208 WOLFE STREET
MOORE SQUARE
HISTORIC DISTRICT (HOD-G)

Nature of Project:
Master landscape/hardscape plan to include: remove existing asphalt surface in parking lot; install decomposed granite surface; install new asphalt; alter existing brick paver sidewalk; remove trees; plant trees; alter plantings in existing beds

APPLICATION FOR A CERTIFICATE OF APPROPRIATENESS – STAFF REPORT

002-18-CA 208 WOLFE STREET
Applicant: HAKAN MARKET PARTNERS INC
Received: 12/6/2017 Meeting Date(s):
Submission date + 90 days: 2/7/2018 1) 1/25/2018 2) 3)

TREE REMOVAL INFORMATION

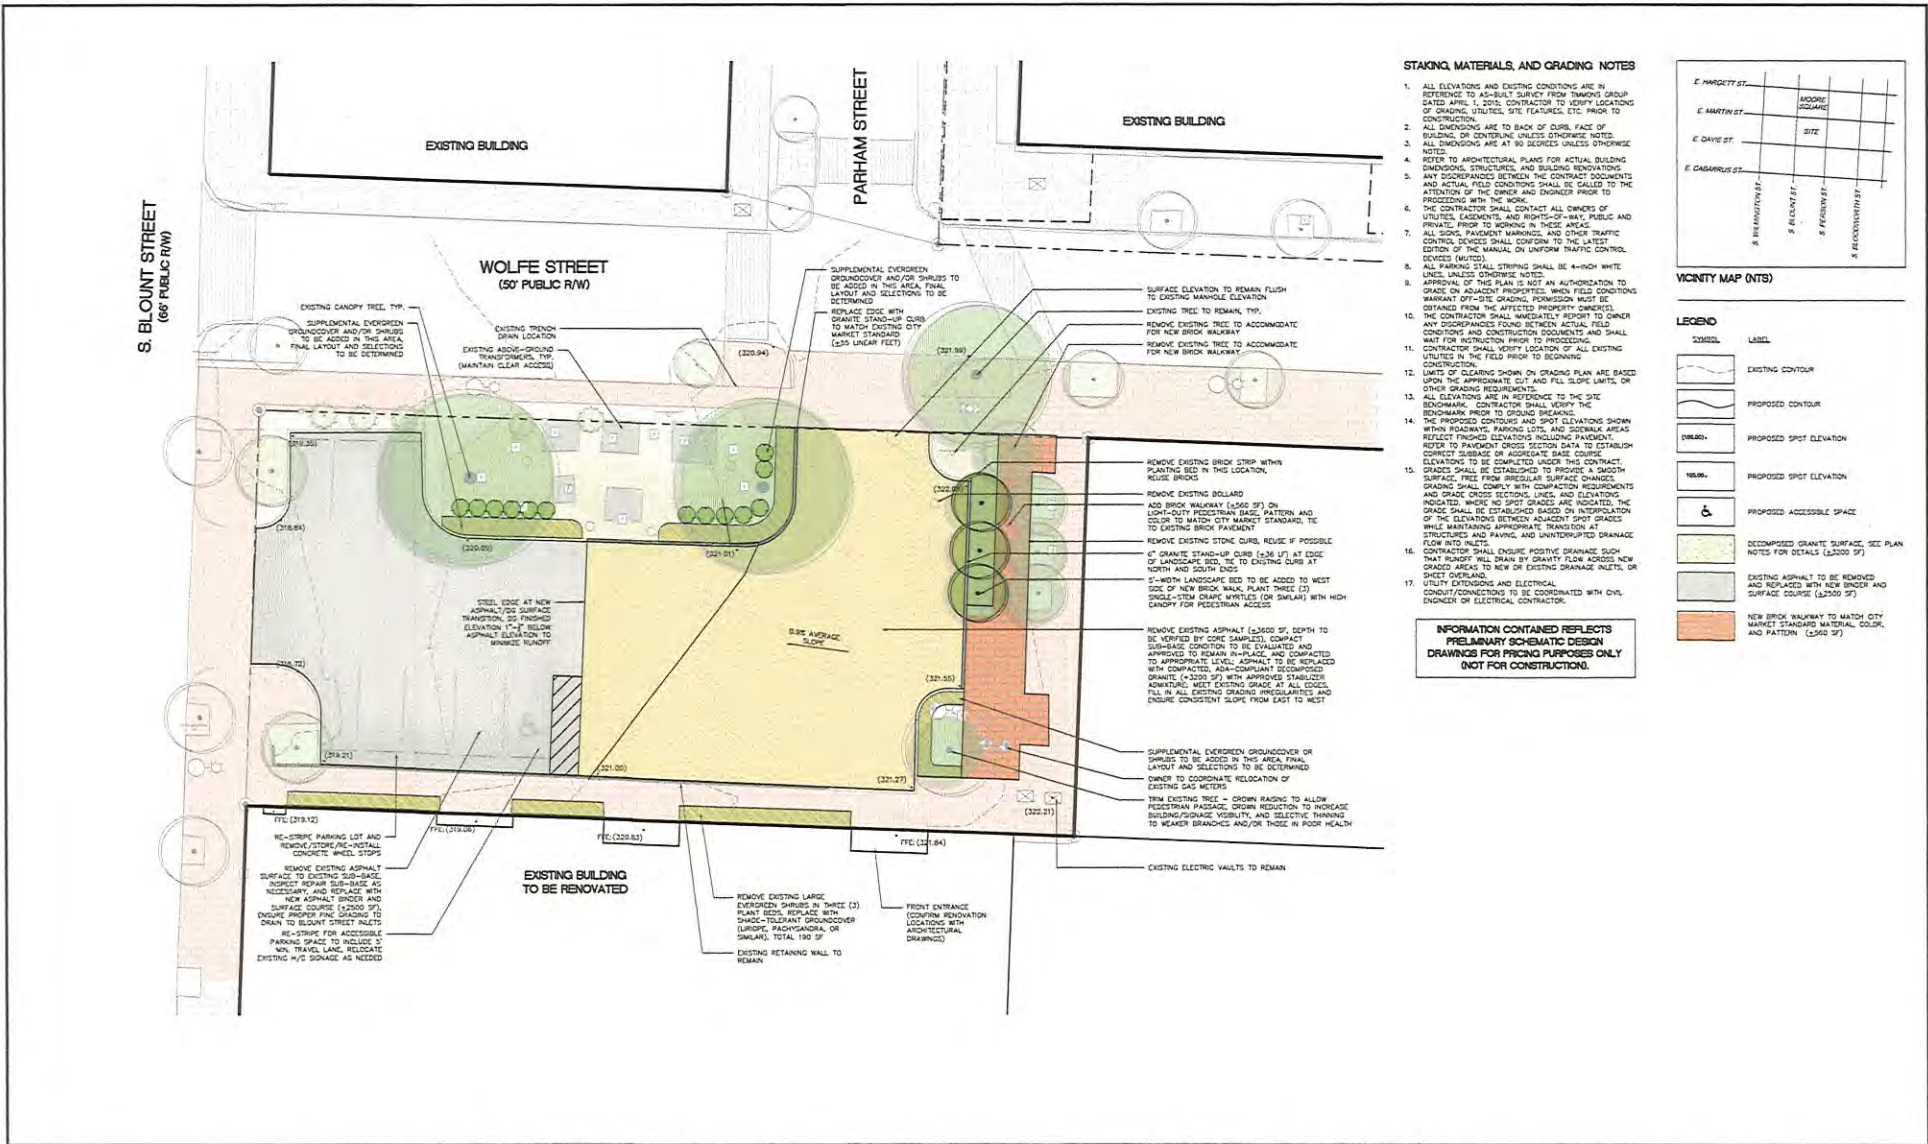
- 1* A 9" caliper Japanese privet tree is proposed to be removed in the northeast corner of the site to allow for an expanded walkway. In the southeast corner, a Chinese pistache is proposed to be trimmed.
- 2* Three single-stem crape myrtles will be planted on the east side of the site along the newly expanded walkway.
- 3* A tree protection plan was provided.
- 4* Existing planting areas are to be replanted and additional planting areas will be added, including around the large area with mechanical equipment on the north edge of the property. Final plant selections were not included in the application.

1. That there be no demolition delay for the removal of the trees.
2. That tree protection plans be implemented and remain in place for the duration of construction.
3. That details and specifications for the following be provided to and approved by staff prior to installation or construction:
 - a. Final plant selections.

C-1.0
Sheet

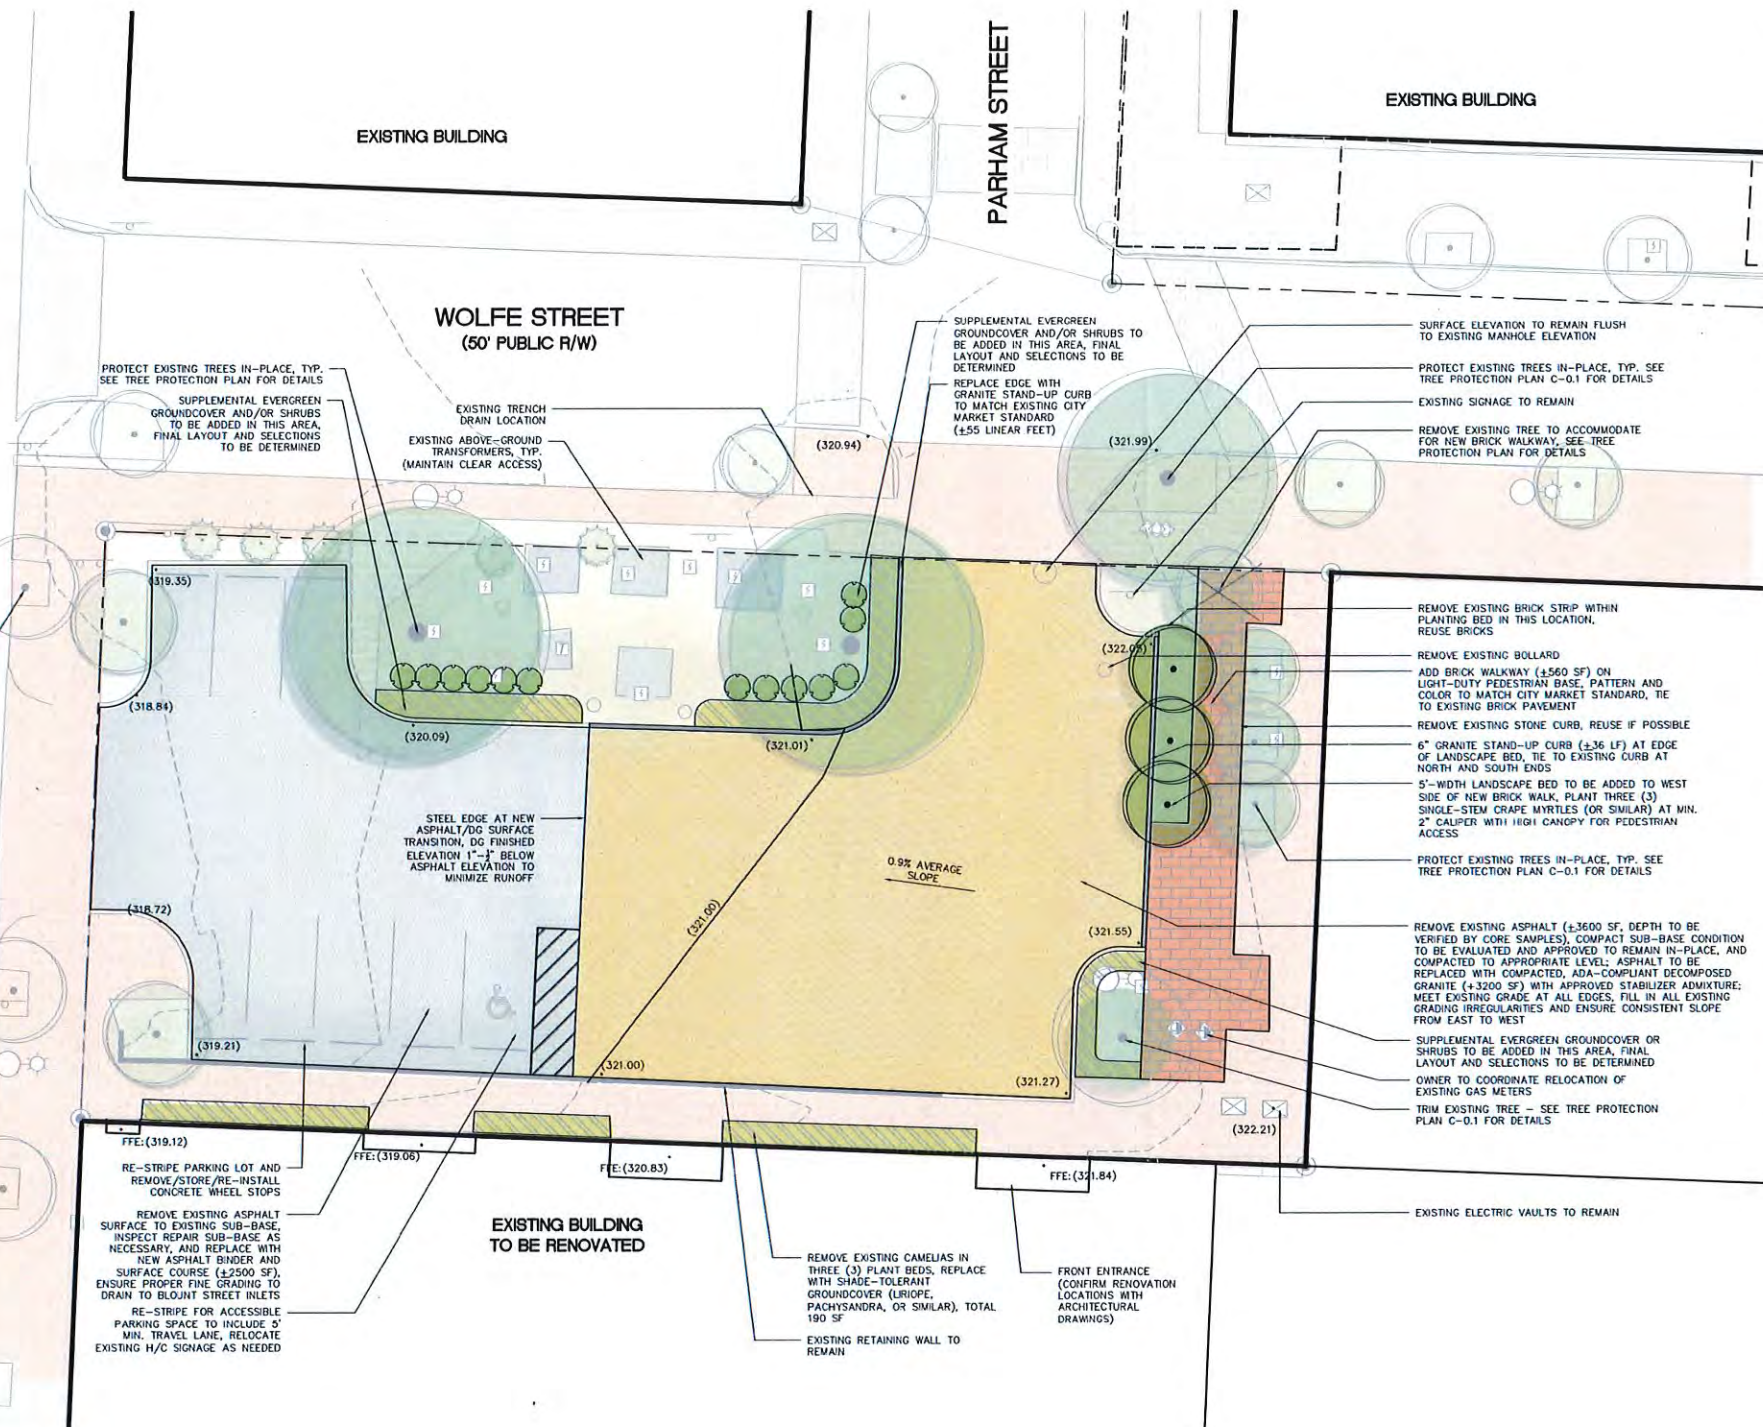
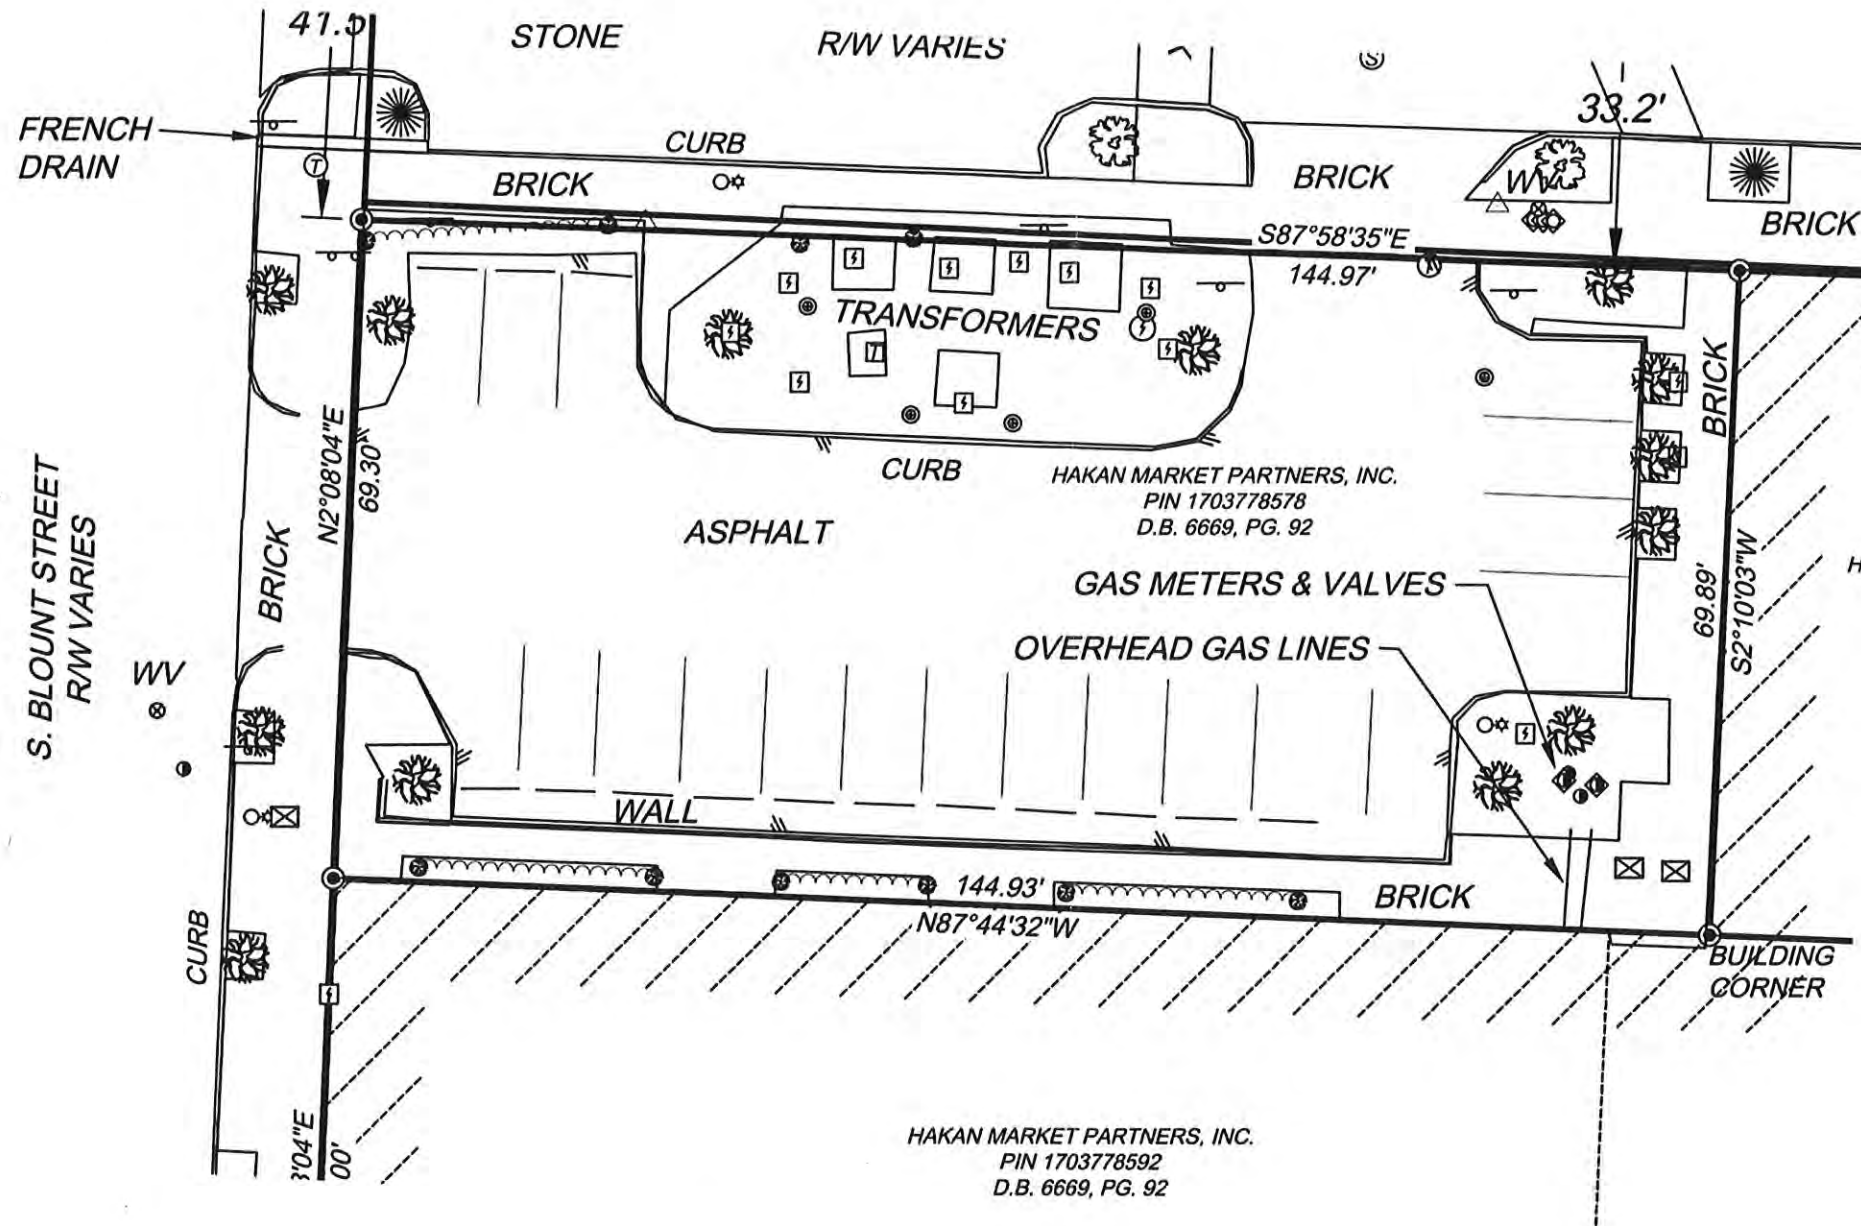
- 4* The existing asphalt parking surface is proposed to be removed and replaced by two different surfaces; decomposed granite on the east of the site and new asphalt on the west. The application calls for Chapel Hill Gravel as the decomposed granite material, which is designed for walkways, patios, plazas and other pedestrian surface areas. The decomposed granite is shown in sample photographs as a beige material with a muted clay tone. No other examples of this material were shown in the Moore Square Historic District.

- 6* The narrow brick walkway at the east end of the site will be widened.
- 7* Granite curb material may require replacement in two areas according to the applicant, both at the revised Wolfe Street entrance entirely within the existing parking lot area.

- 8* No changes in granite curbs, curb cuts, sidewalks or driveway aprons in the public right-of-way are proposed.

Pending committee discussion on the decomposed granite surface material, staff suggests that the committee approve the application with the following conditions:
